# UNITED STATES PATENT AND TRADEMARK OFFICE

APPLICATION NO.	FILING DATE	FIRST NAMED INVENTOR	ATTORNEY DOCKET NO.	CONFIRMATION NO.
10/670,981	09/25/2003	Harry Eugene Flynn	KMG1097-US1	8092
36732	7590	05/18/2005	EXAMINER	
LAW OFFICE OF STANLEY K. HILL, PLC			NICHOLSON, ERIC K	
P.O. BOX 52050			ART UNIT	
MINNEAPOLIS, MN 55402			PAPER NUMBER	
			3679

**Office Action Summary**

**DETAILED ACTION**

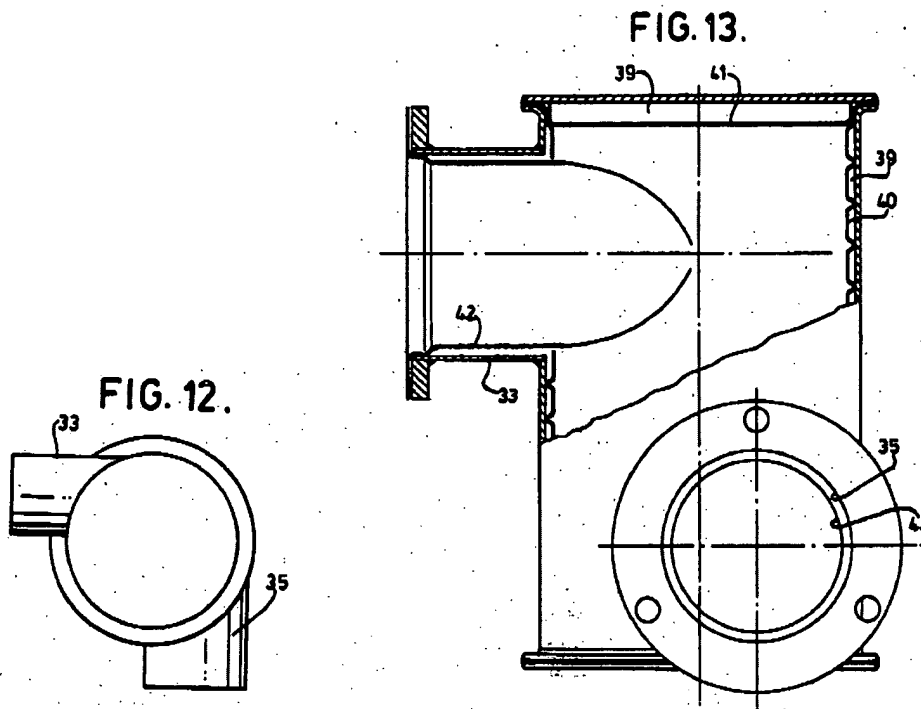
Claims 12,13,15,16,17 and 19 rejected under 35 U.S.C. § 102(b) as being anticipated by U.S. patent 4,301,651 to Cocchiara et al.. The Cocchiara elbow as shown in figs. 12 and 13 (see below) illustrates the present invention with a cylindrical body and tangential inlets and outlets wherein the body includes a liner 40 and the inlets and outlets also include liners 42. The liners can be removed by any number of means.
